**PROPOSED MIDDELWATER CLASS B  
WASTE FACILITY**

**ADDENDUM TO DESIGN REPORT**

**REVISION 2**

**Ref. No.755-2022  
January 2026**

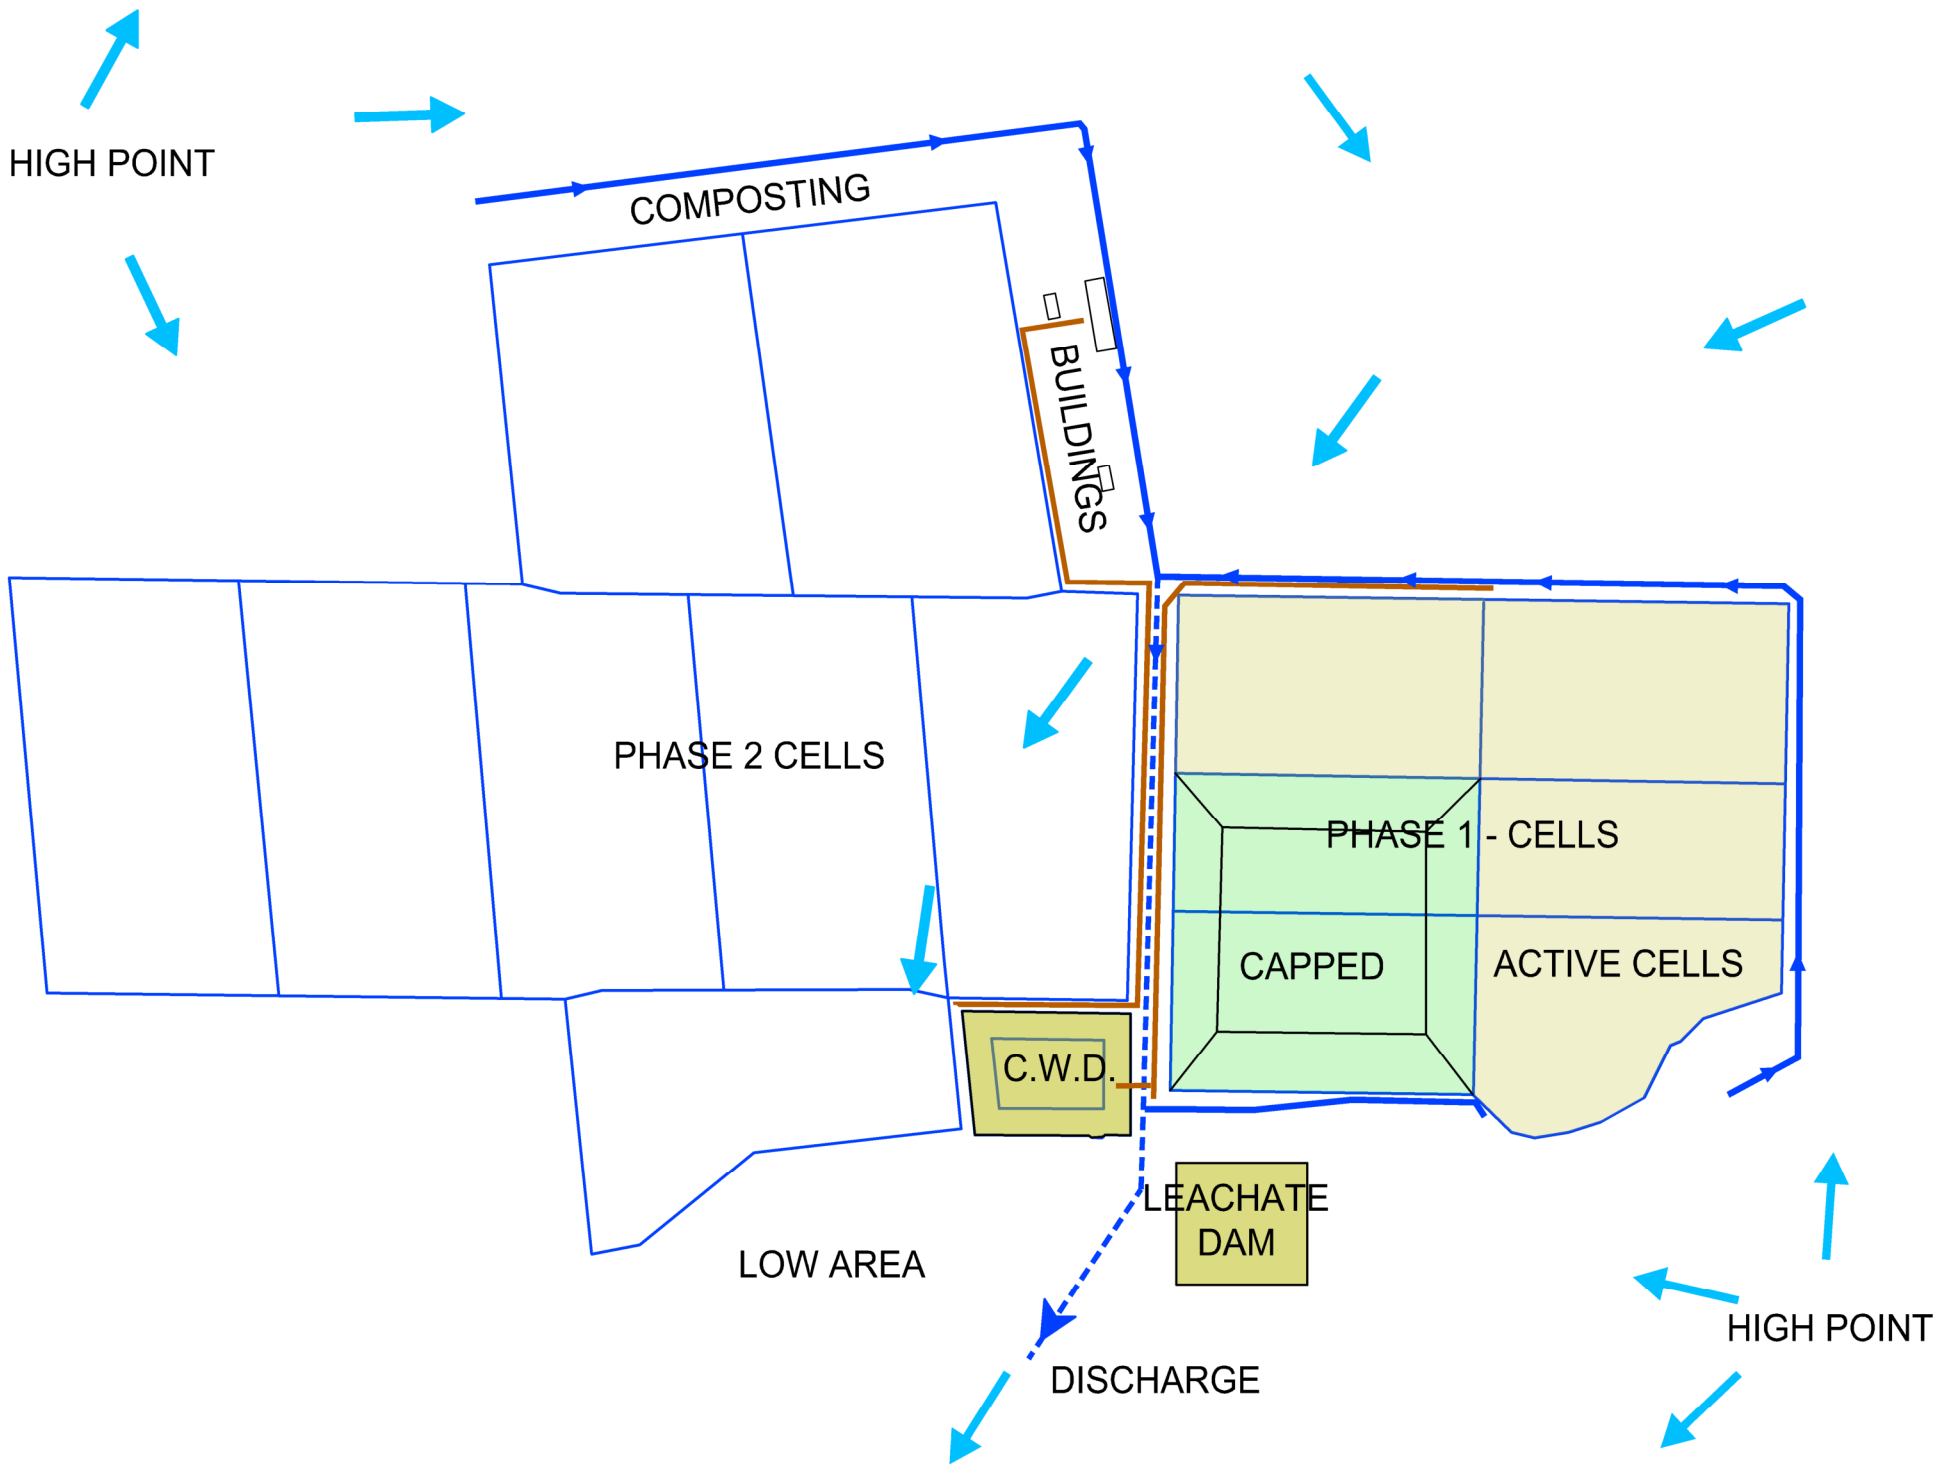
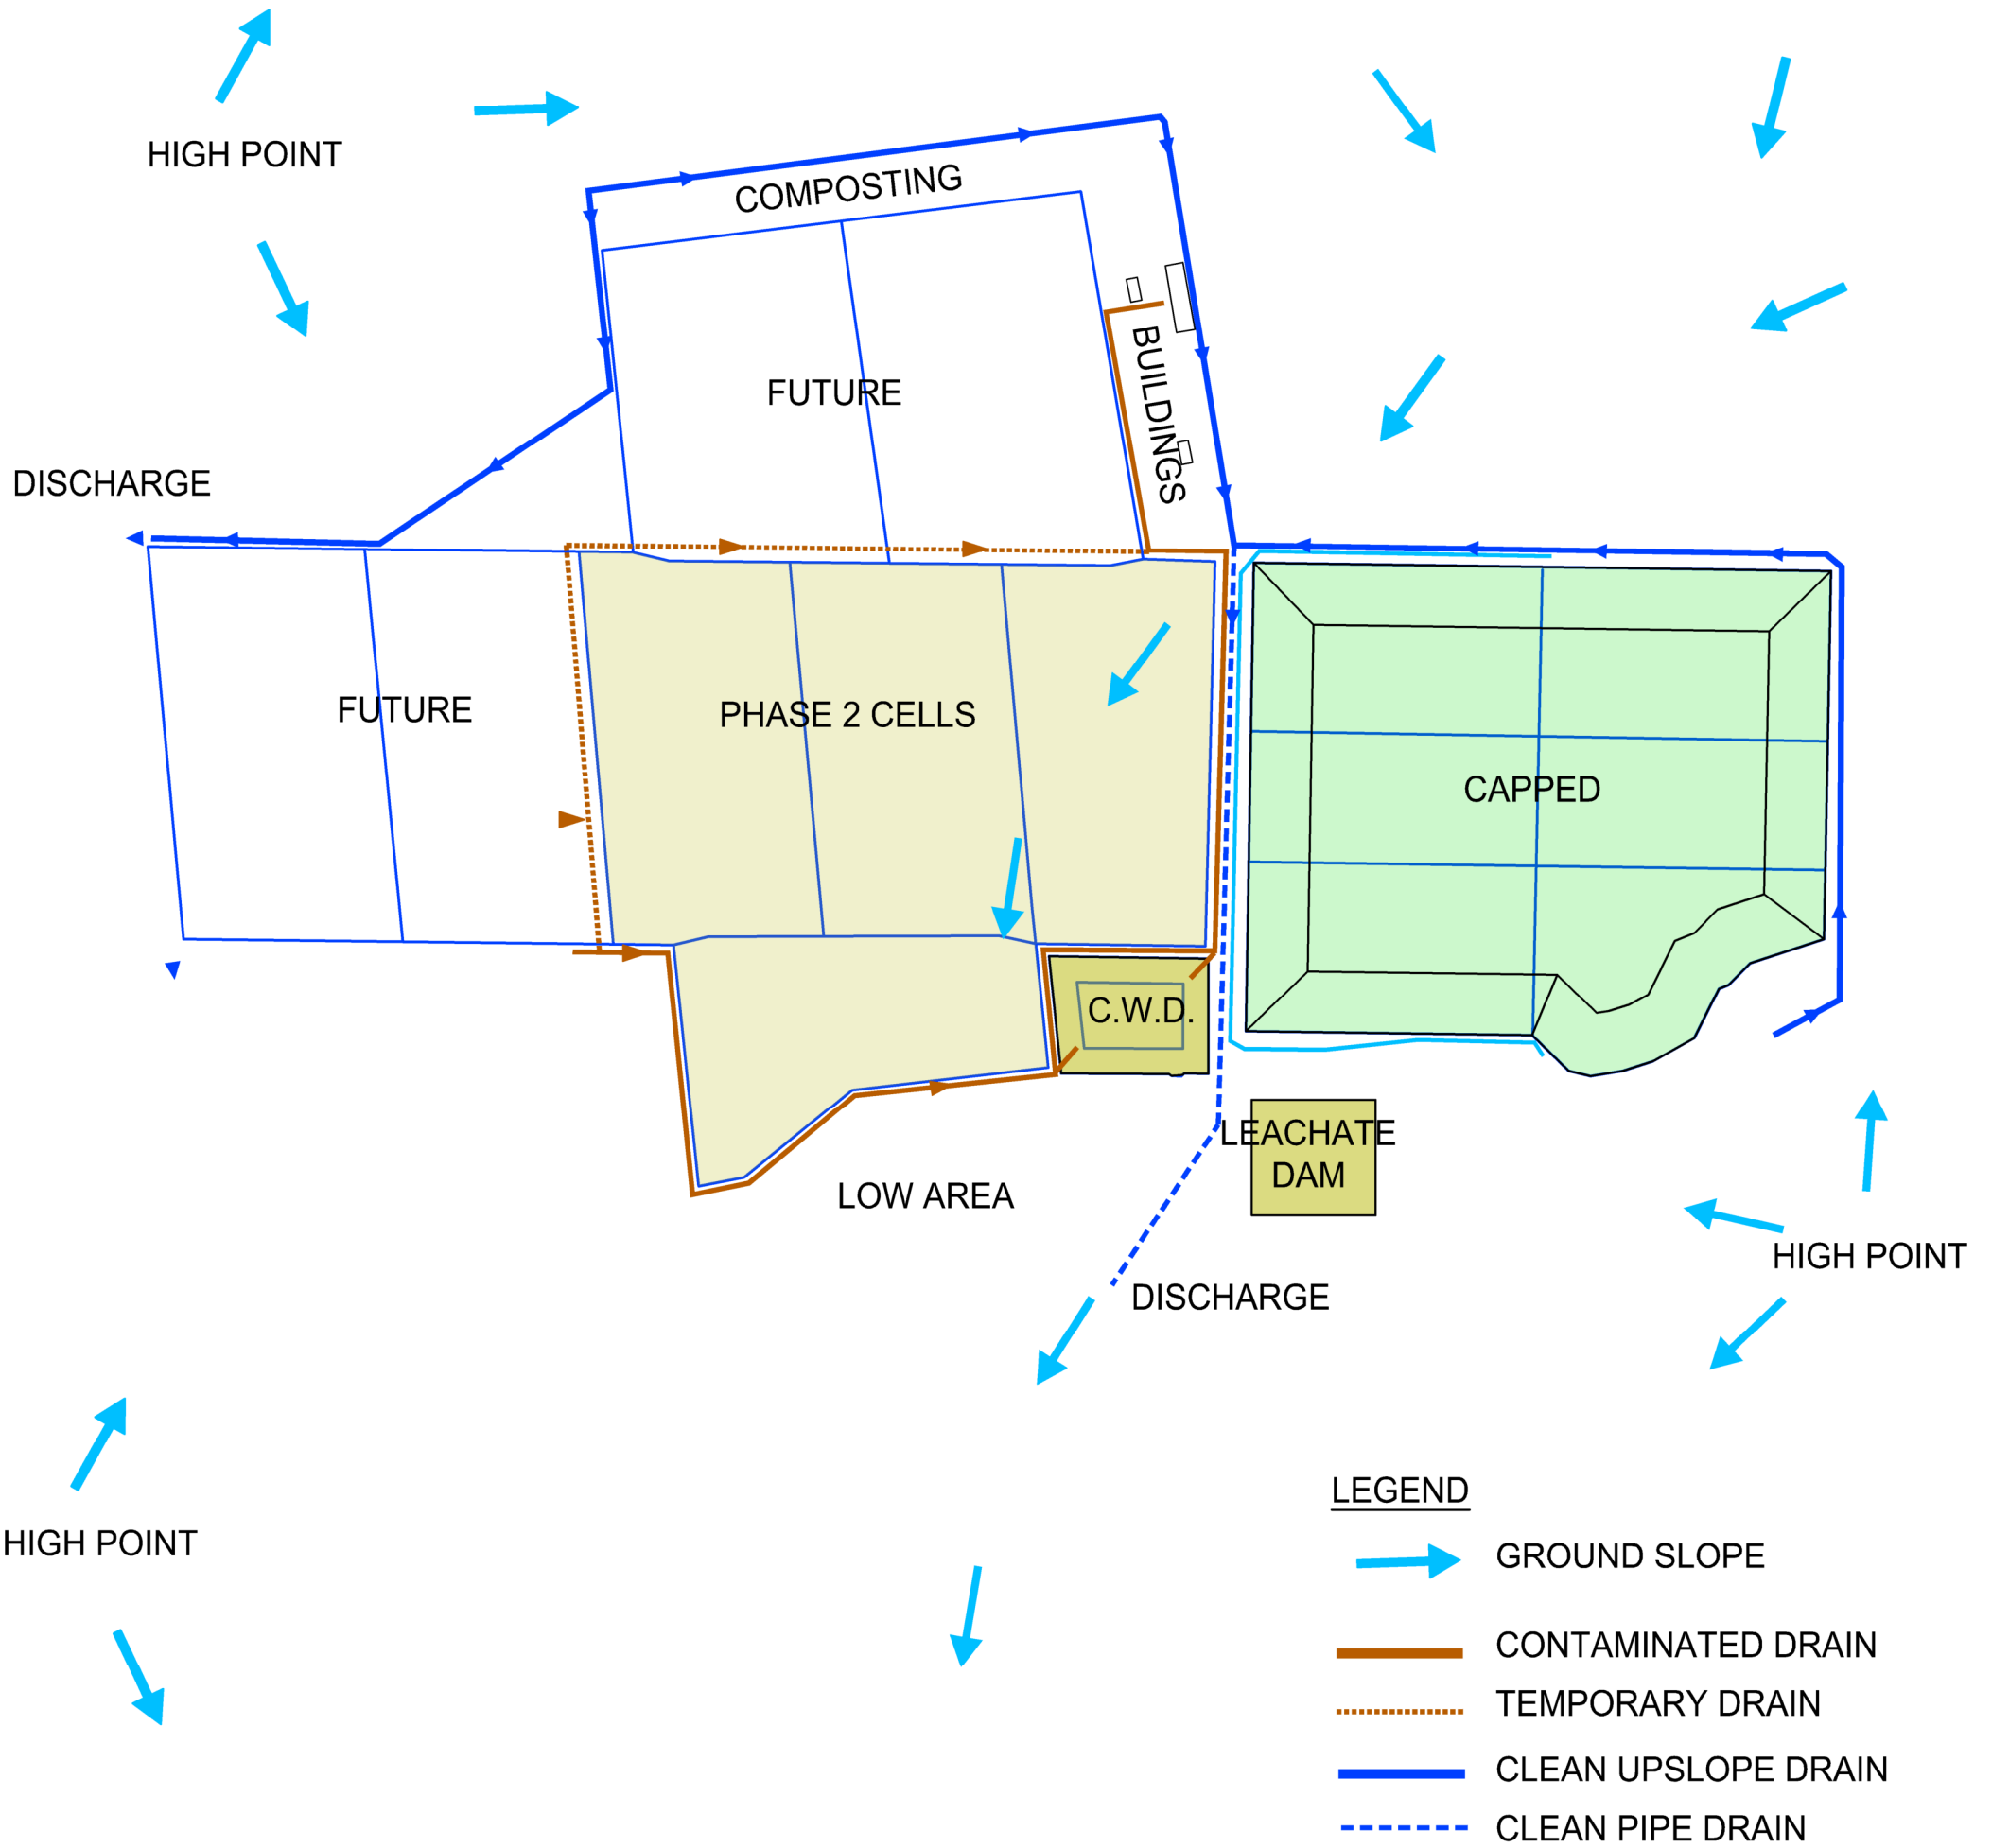
2.1	<p>Middelwater Resource Facility (Pty) Ltd must provide a flow diagram identifying the source and destination of clean stormwater runoff, polluted stormwater runoff, and leachate, recognising the change to runoff areas with time.</p>	Envitech	<p>Envitech to show a diagram for clean stormwater, polluted water separation per phase. See sketches at the 755-2022-SK01 to SK05 with the project drawings.</p>

- 2.1 Middelwater Resource Facility (Pty) Ltd must provide a flow diagram identifying the source and destination of clean stormwater runoff, polluted stormwater runoff, and leachate, recognising the change to runoff areas with time.
